ADDRESS: 5458 California Avenue SW
Seattle, WA 98136

PROJECT #: 3024224

8.0 ITEMIZED RESPONSE TO EDG

9.0 GROUND FLOOR PLAN

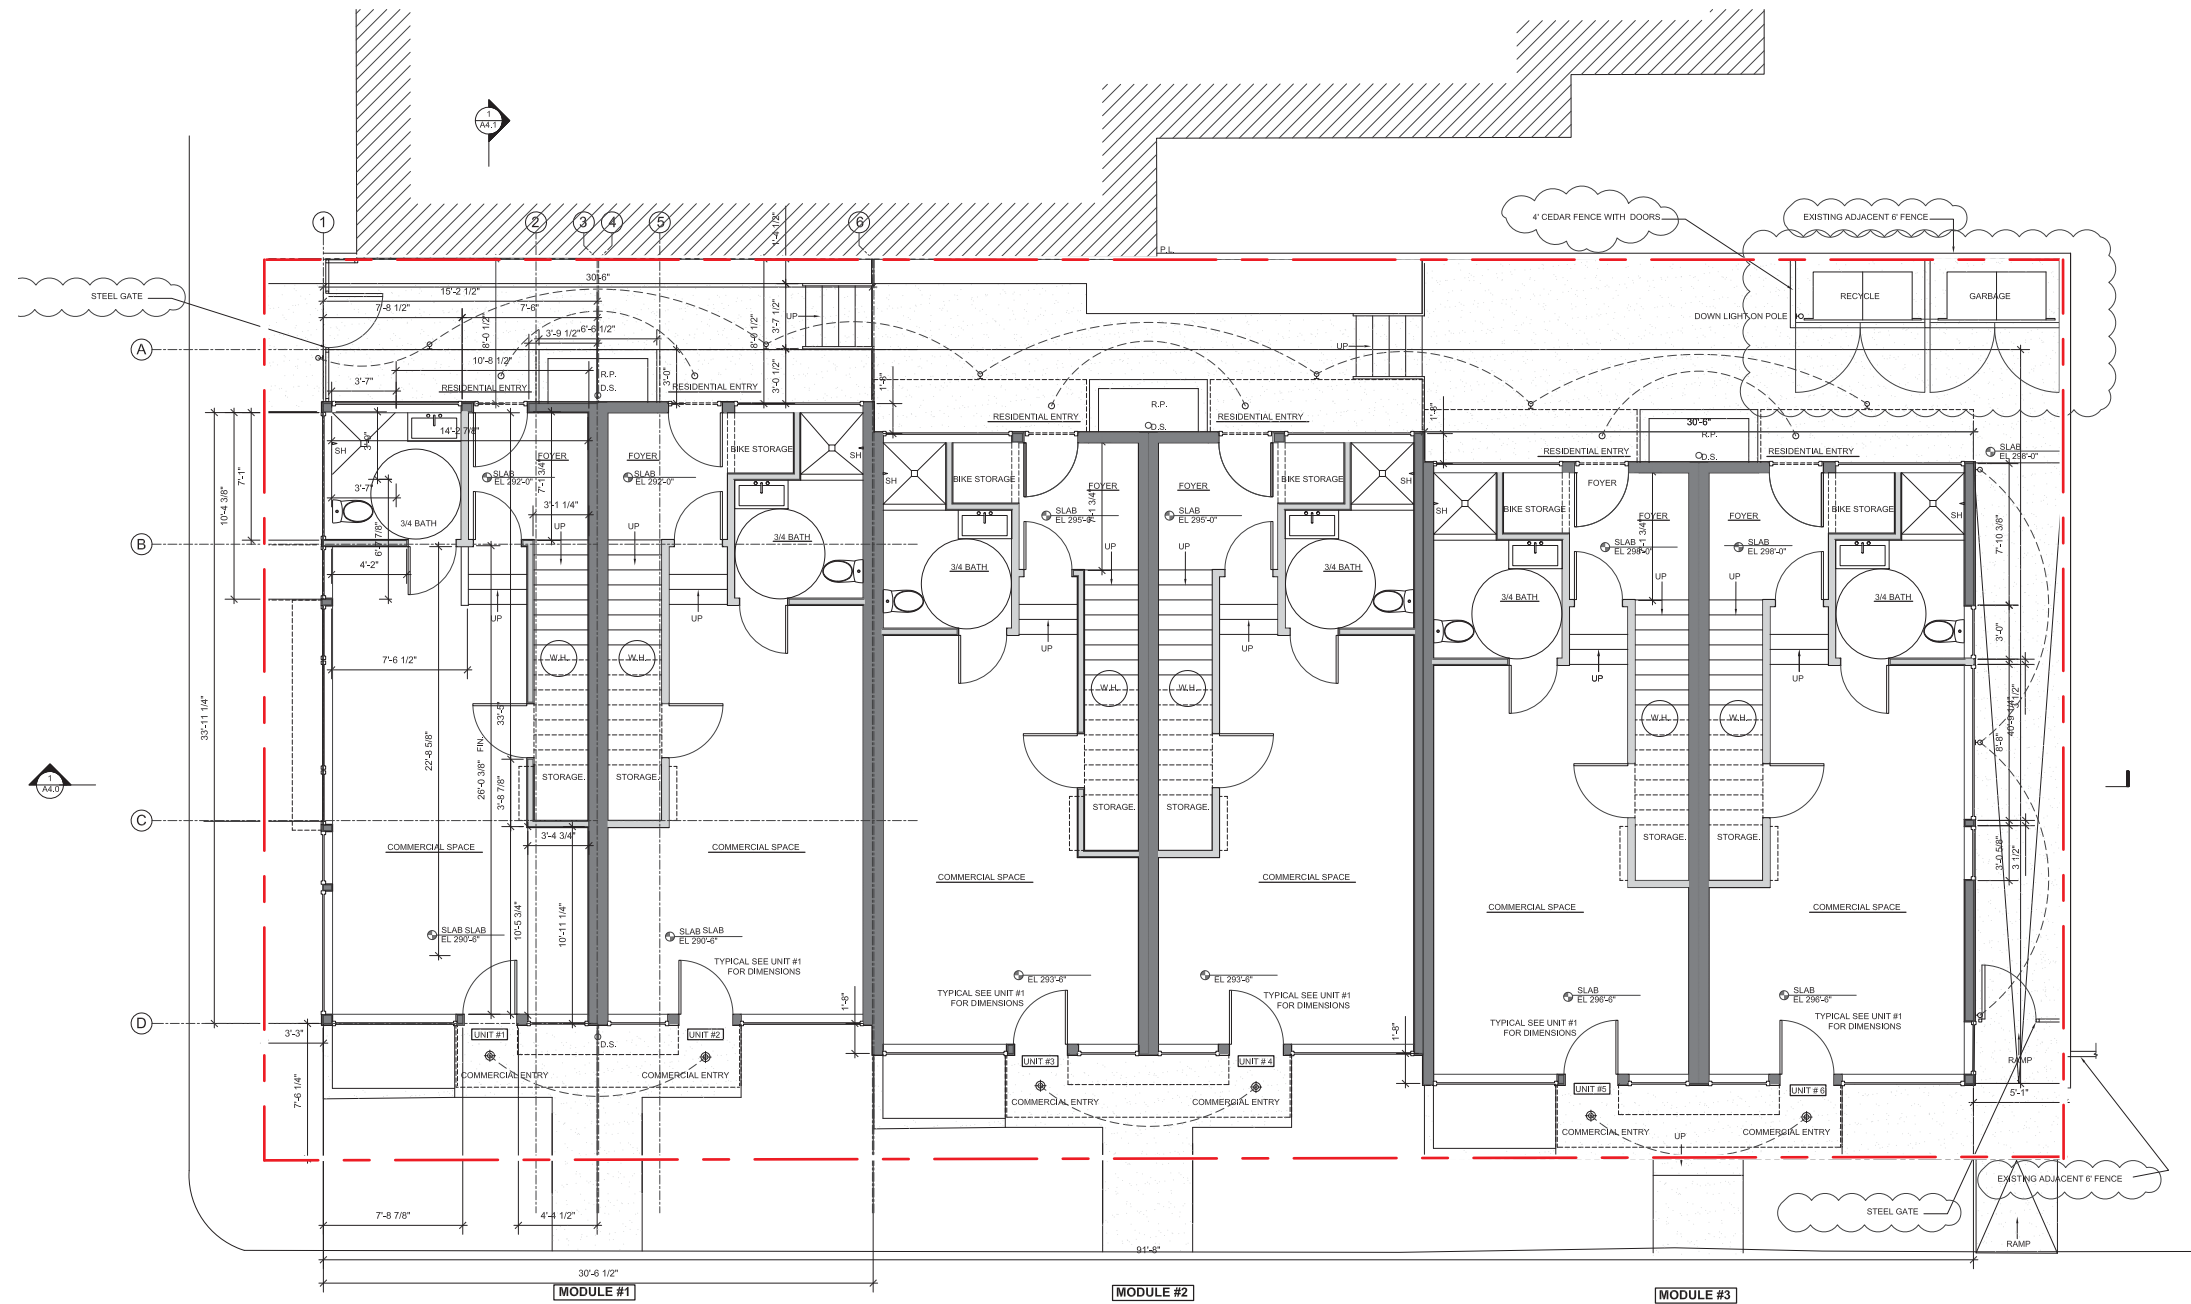
The Board directed further resolution of the garbage staging area and to accurately show the area on the plans. DC1-C

See added detail on Ground Floor Plan on page 10.

11.0 ELEVATIONS

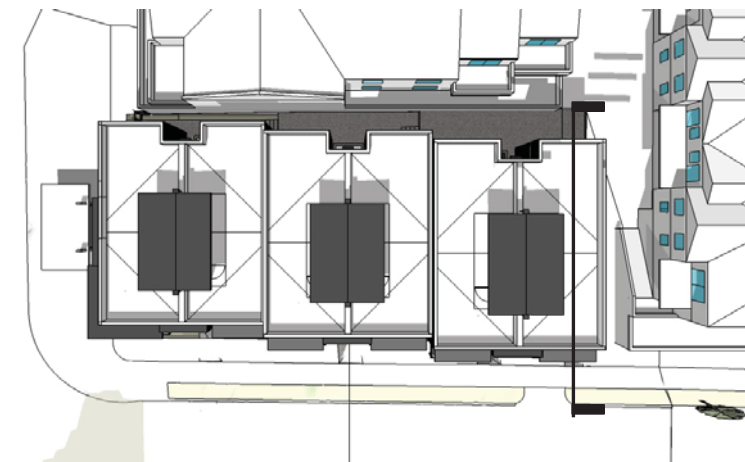
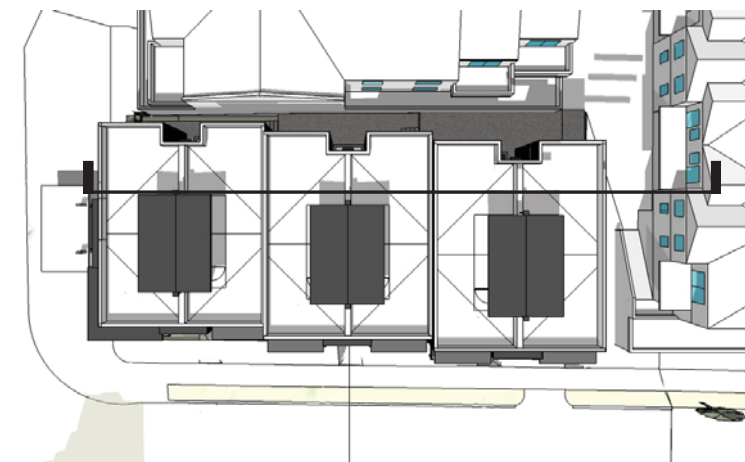
On the east elevation please resolve where the flat panel is wrapped within the window band. Perhaps the bottom band could carry through to match the language of the top band (in between the windows). This seems to be shown on the elevation sheet A2.1, please reflect this in the provided rendering. Provide window overlay/privacy study.

Windows facing East are generally placed high on the walls to avoid creating privacy issues. Windows at the southeast corner will not face directly into the neighboring building as it is stepped back from the street.

Windows from the western three units pose no privacy issues as the building to the north of those units is a blank wall. Other windows align only at the clerestory level with the first floor, behind which, raised beds will house screening plantings. In the far eastern unit, where the live-work building and the building to the north are both set back from the property line, the kitchen window aligns with a window set behind a deck in the building to the north.

14.0 EXTERIOR LIGHTING PLAN

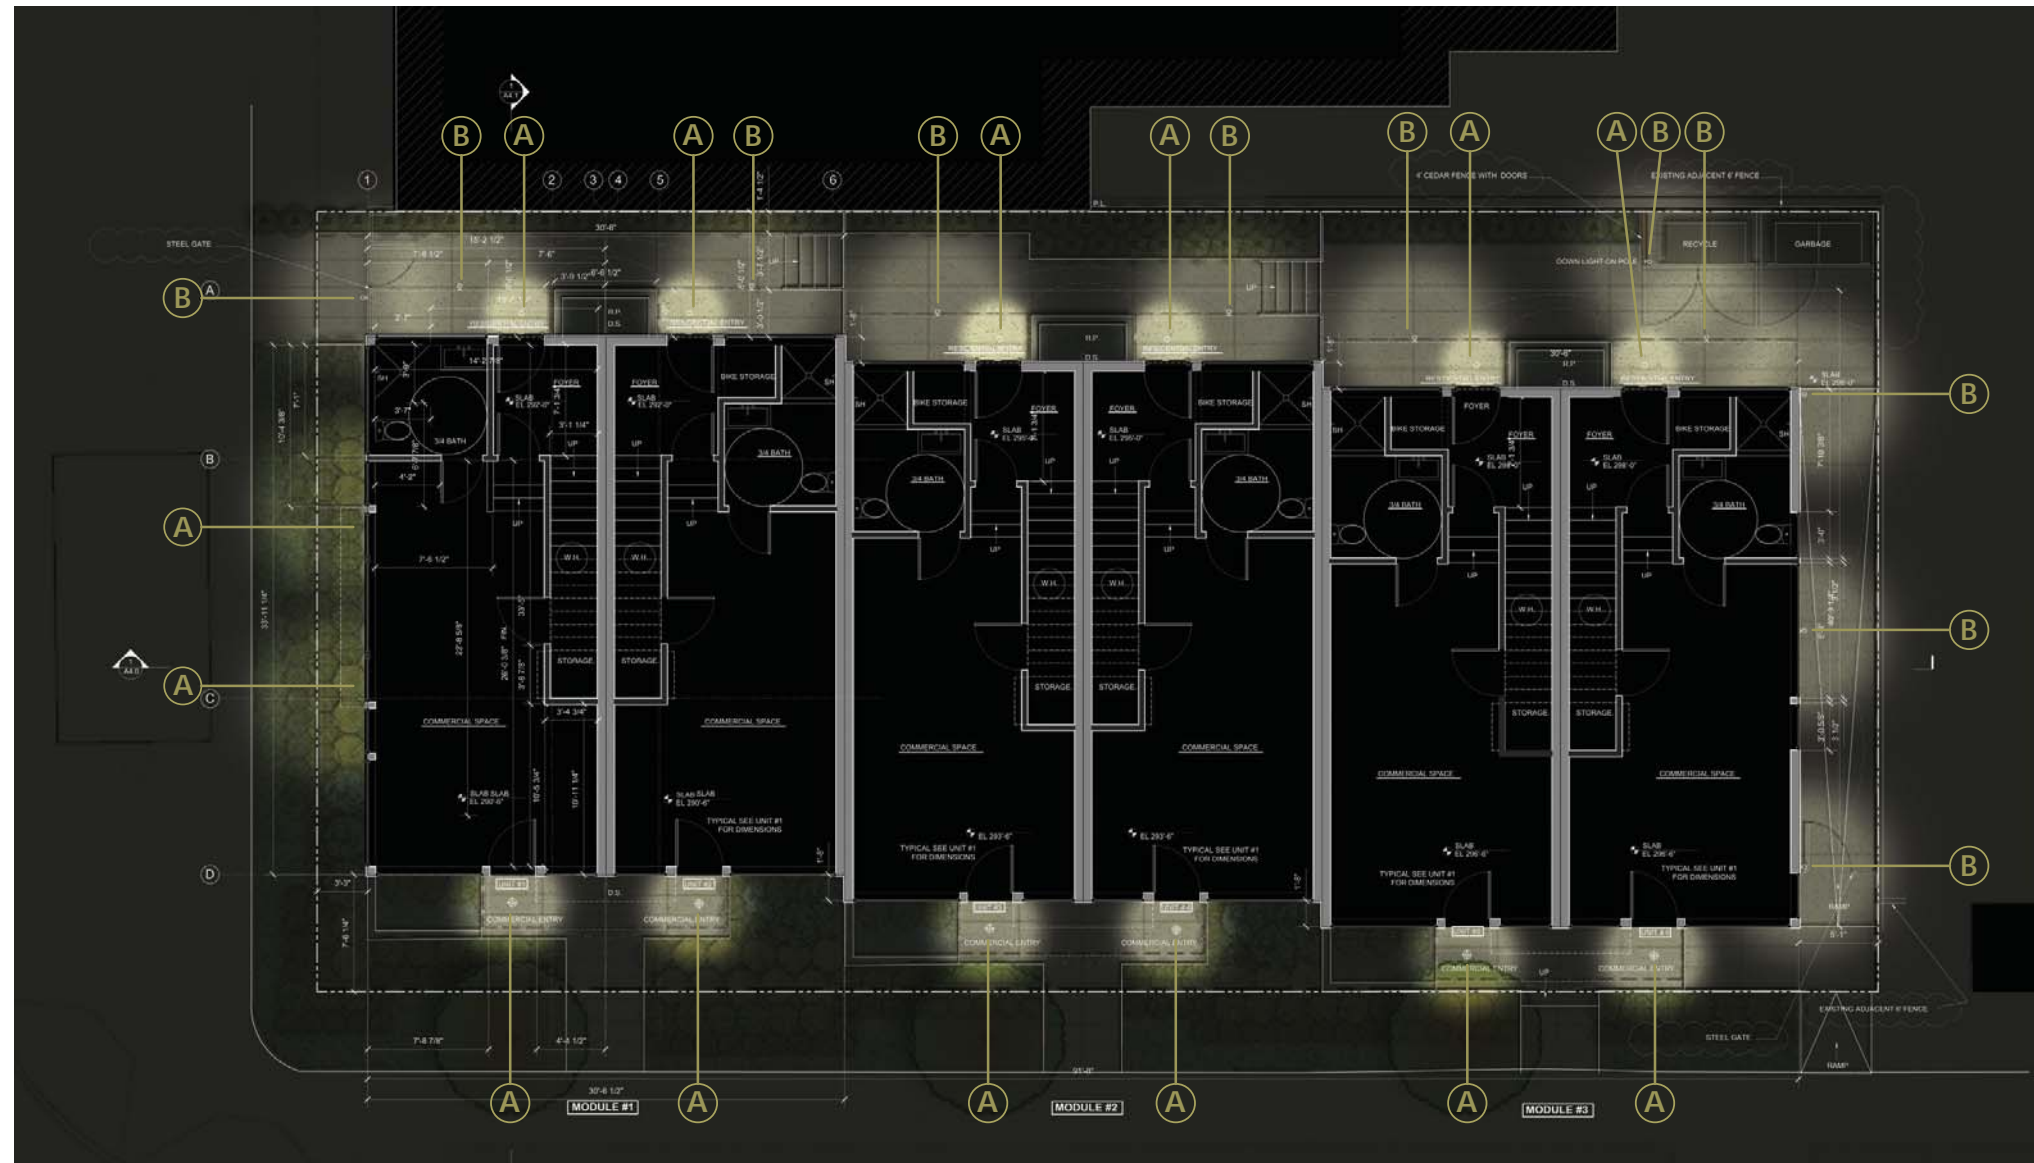
1. Further clarify the intention to gate the site and how this would be located and designed.
2. At the next meeting and site lighting for security. PL2-B, DC4-C

1. Please see plans and elevations.
2. See blown up Exterior Lighting Plan on sheet 29 for site lighting diagram with fixtures and callouts.

15.0 SIGNAGE CONCEPT PLAN

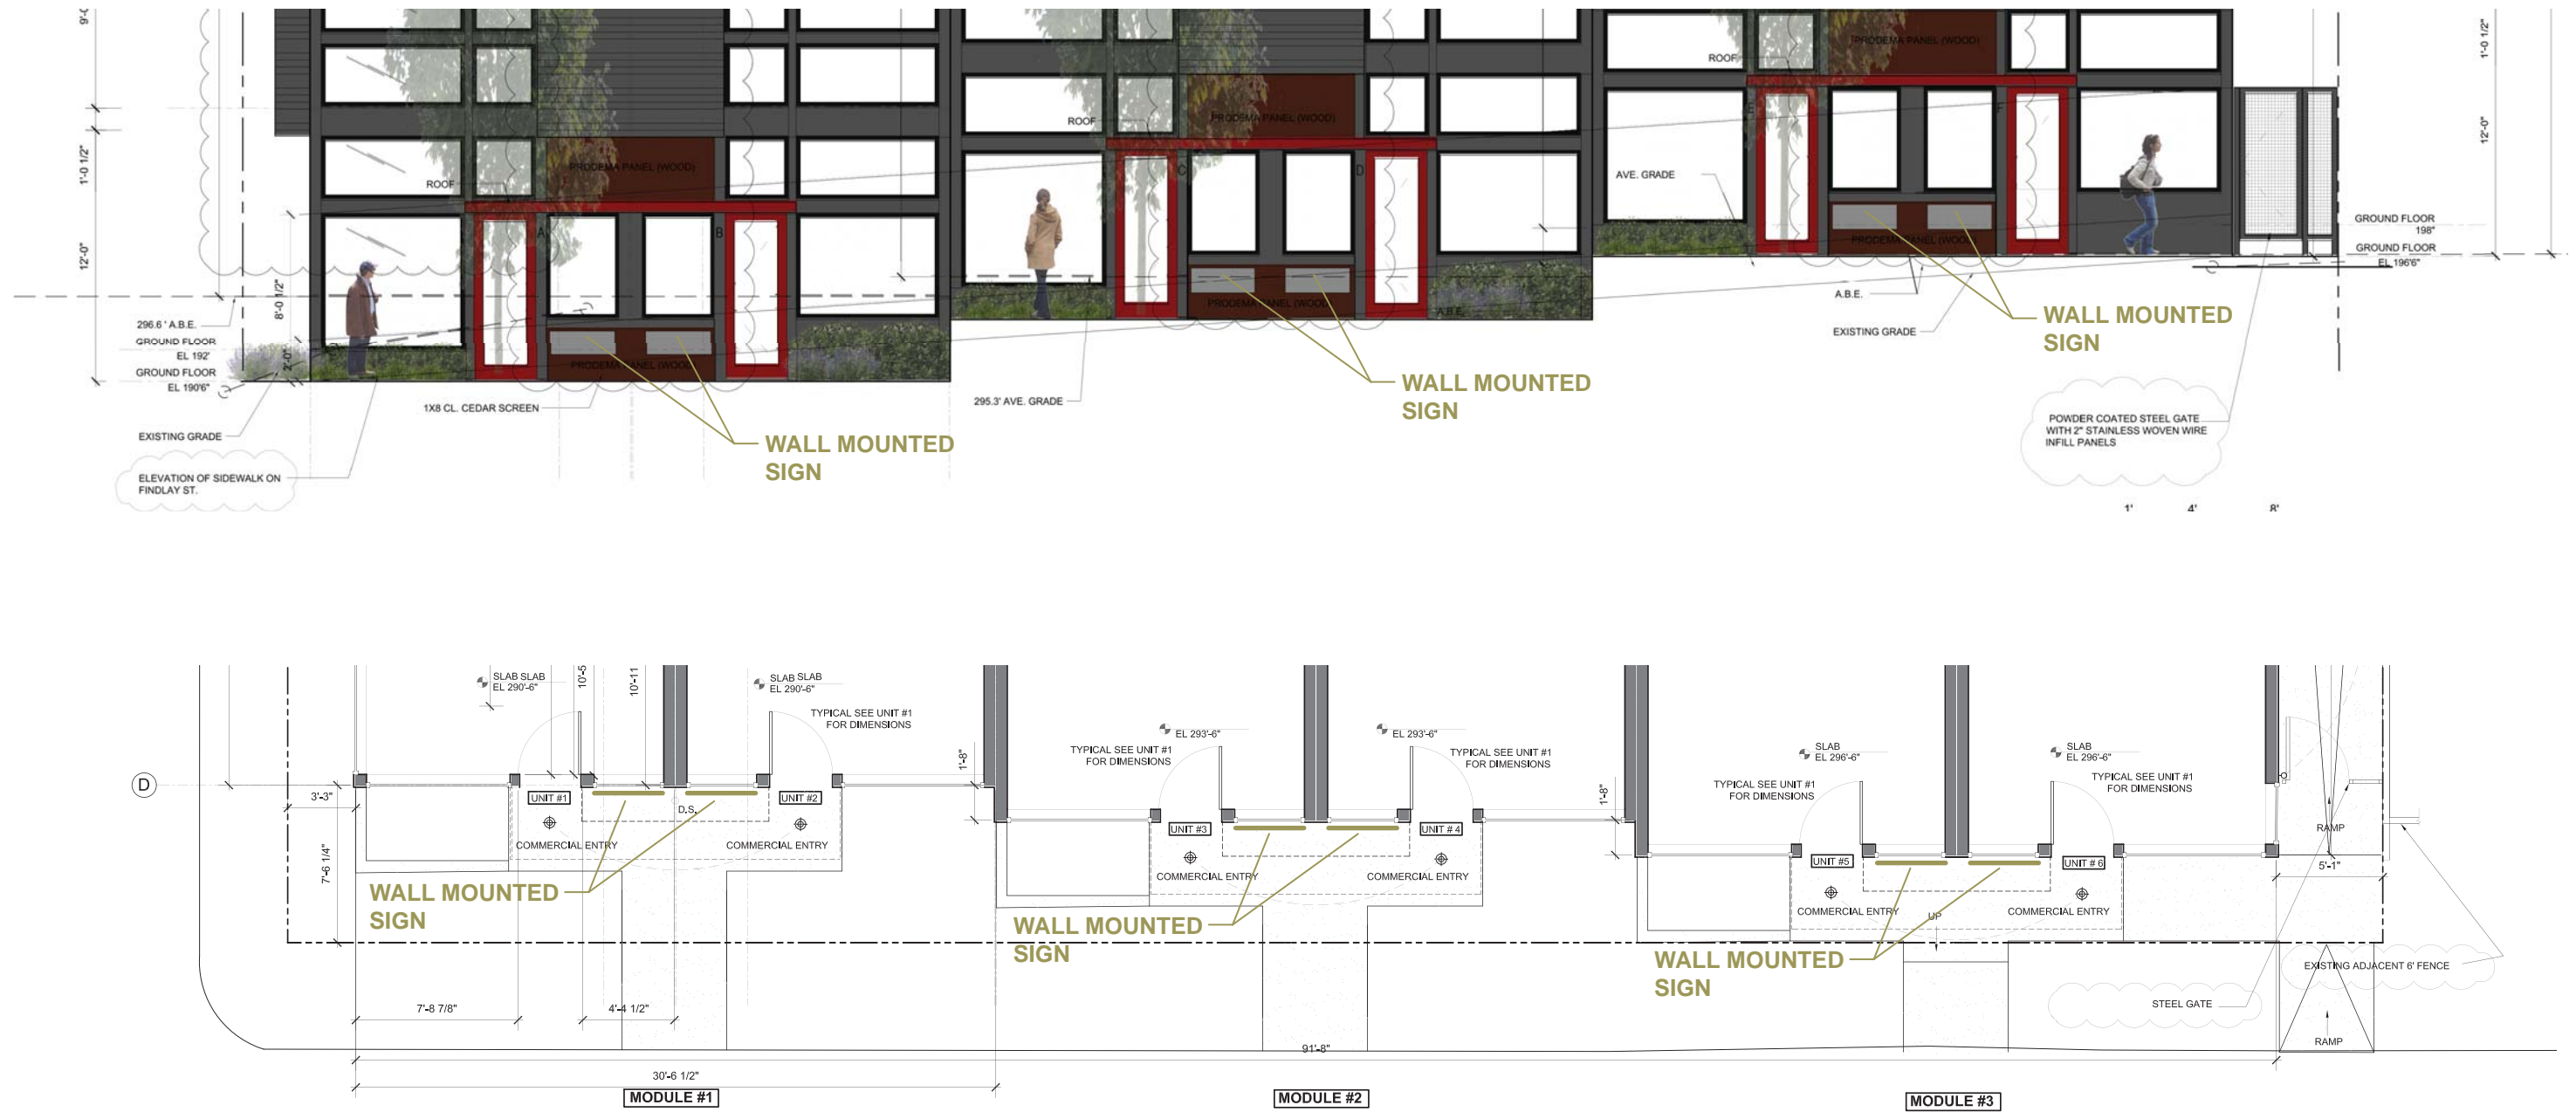
At the next meeting provide details on the lighting and signage for the live/work businesses. DC4-B, DC2-C

See Signage Concept Plan on sheet 30.
